Technical Service Bulletin: tsb100524

Released Date: 25-Oct-2006

Revised Exhaust Manifold Part Numbers

14a00016

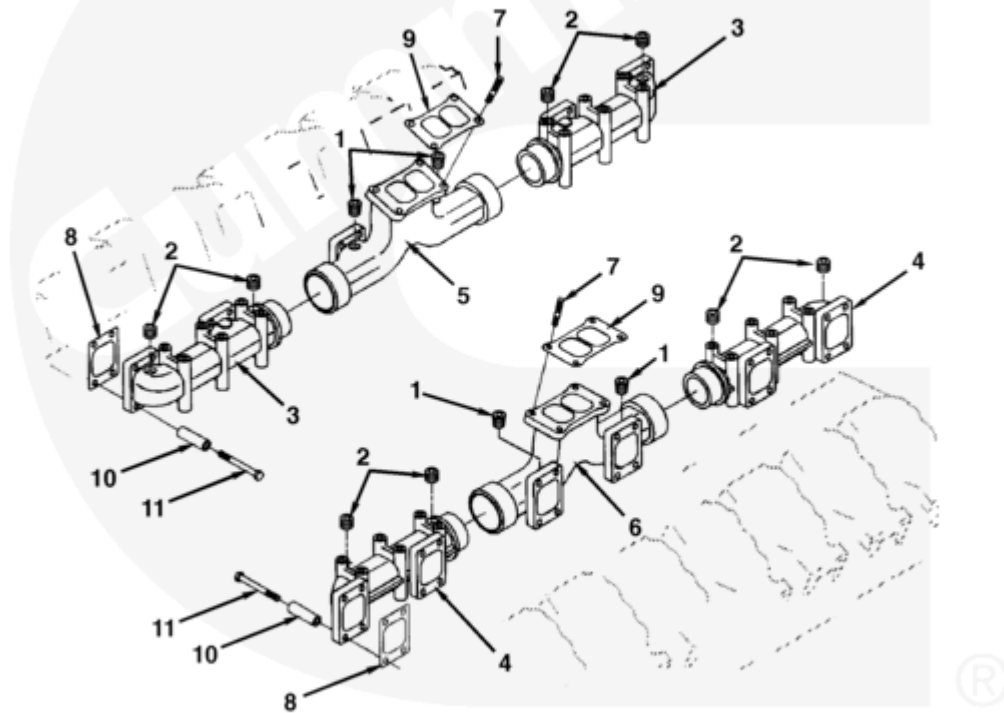
This Technical Service Bulletin lists which exhaust manifold part numbers are required for each manifold configuration on QST30 engines. The manifold part numbers are categorized by exhaust manifold option (TBXXXX) and by front out or rear out exhaust configurations.

Front Out Exhaust Manifold Configurations				
Exhaust Manifold Option	Bank	Front	Center	Rear
TB5712	Left	3092658	3092659	3092657
	Right	3092657	3092660	3092658
TB5713	Left	3092062	3092063	2092061
	Right	3092061	3092064	3092062
TB5718	Left	3092658	3092534	3092657
	Right	3092657	3092533	3092658
TB5722	Left	3092062	4067920	3092061
	Right	3092061	4067921	3092062
TB5728	Left	3092658	3092534	3092657
	Right	3092657	3092533	3092658
TB5730	Left	3092062	4067920	3092061
	Right	3092061	4067921	3092062
TB5732	Left	3092658	4295291	3092657
	Right	3092657	4295293	3092658
TB5733	Left	3092062	4295454	3092061
	Right	3092061	4295456	3092062

Rear Out Exhaust Manifold Configurations				
Exhaust Manifold Option	Bank	Front	Center	Rear
TB5712	Left	3092658	3092660	3092657
	Right	3092657	3092659	3092658
TB5713	Left	3092062	3092064	2092061
	Right	3092061	3092063	3092062
TB5718	Left	3092658	3092533	3092657
	Right	3092657	3092534	3092658
TB5722	Left	3092062	4067921	3092061
	Right	3092061	4067920	3092062

Rear Out Exhaust Manifold Configurations				
Exhaust Manifold Option	Bank	Front	Center	Rear
TB5728	Left	3092658	3092533	3092657
	Right	3092657	3092534	3092658
TB5730	Left	3092062	4067921	3092061
	Right	3092061	4067920	3092062
TB5732	Left	3092658	4295293	3092657
	Right	3092657	4295291	3092658
TB5733	Left	3092062	4295456	3092061
	Right	3092061	4295454	3092062
